Supplement to the Report of Ground Water Investigation for the Proposed Richmond Semi-Depressed Section- Ground Water Quality Study

04-CC-17, PM 1.3 to 3.9  
47th St. to 6th St.  
04209-108701  
Lab Auth 652907  
August 1979

SUPPLEMENT TO THE  
REPORT  
OF  
GROUND WATER INVESTIGATION  
FOR THE  
PROPOSED  
RICHMOND SEMI-DEPRESSED SECTION  
04-CC-17  
(GROUND WATER QUALITY STUDY)

FIGURE 2

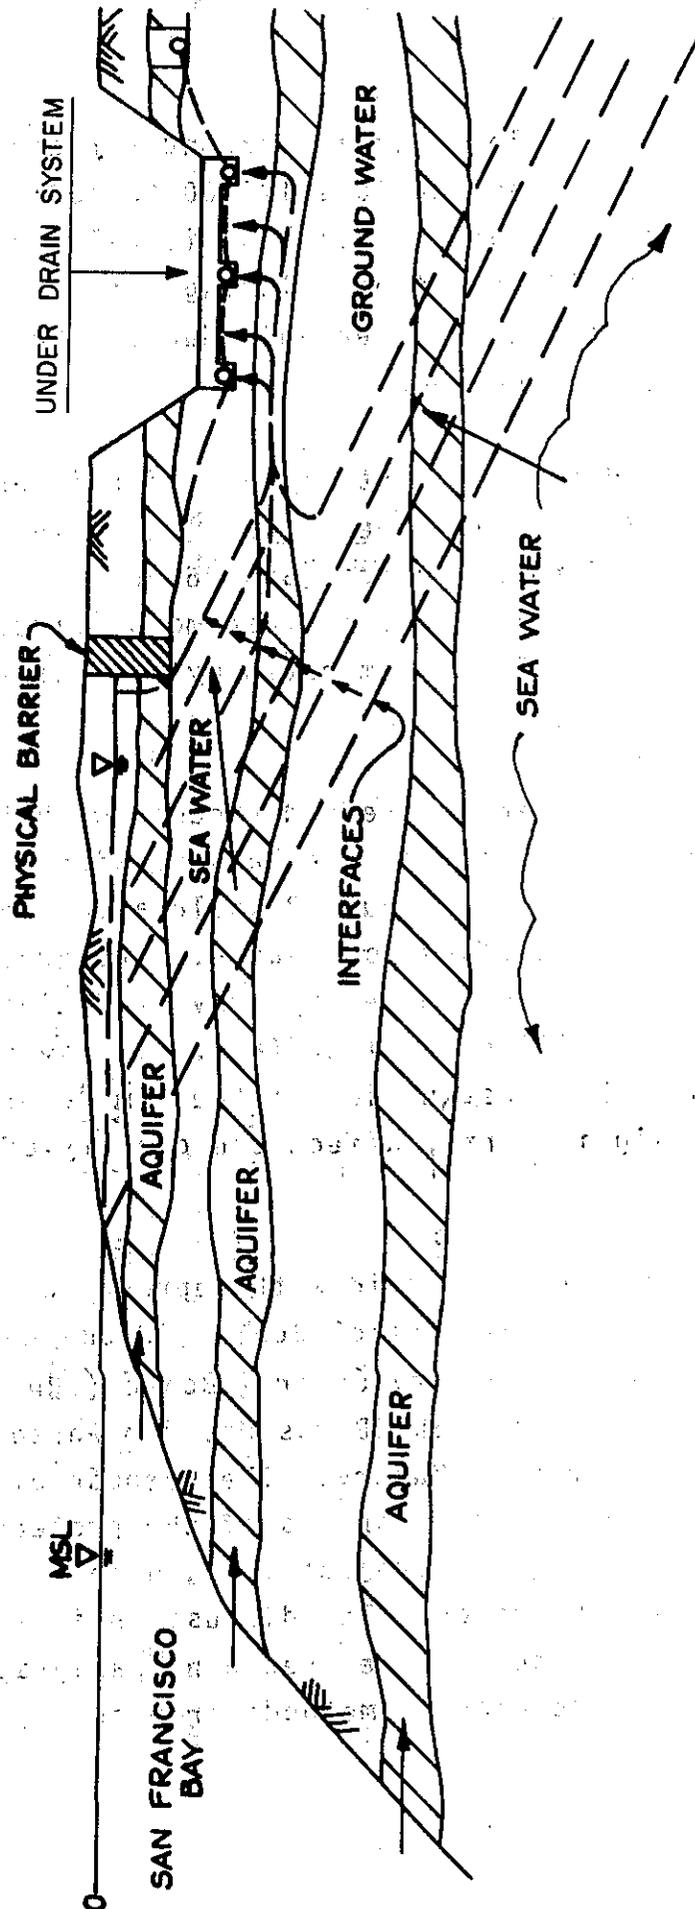
Caltrans could induce some added seawater intrusion within the project area; which was, however, considered to be of no significant concern. The concensus was that there would be no damage to the aquifers in the Contra Costa Ground Water Basin as a result of the freeway construction. Mr. Richard McMurtry also suggested a monitoring system to evaluate the effects of the proposed construction. Mr. McMurtry noted no problems as far as SWRCB and CRWQCB are concerned and asserted he would confirm this decision by letter.
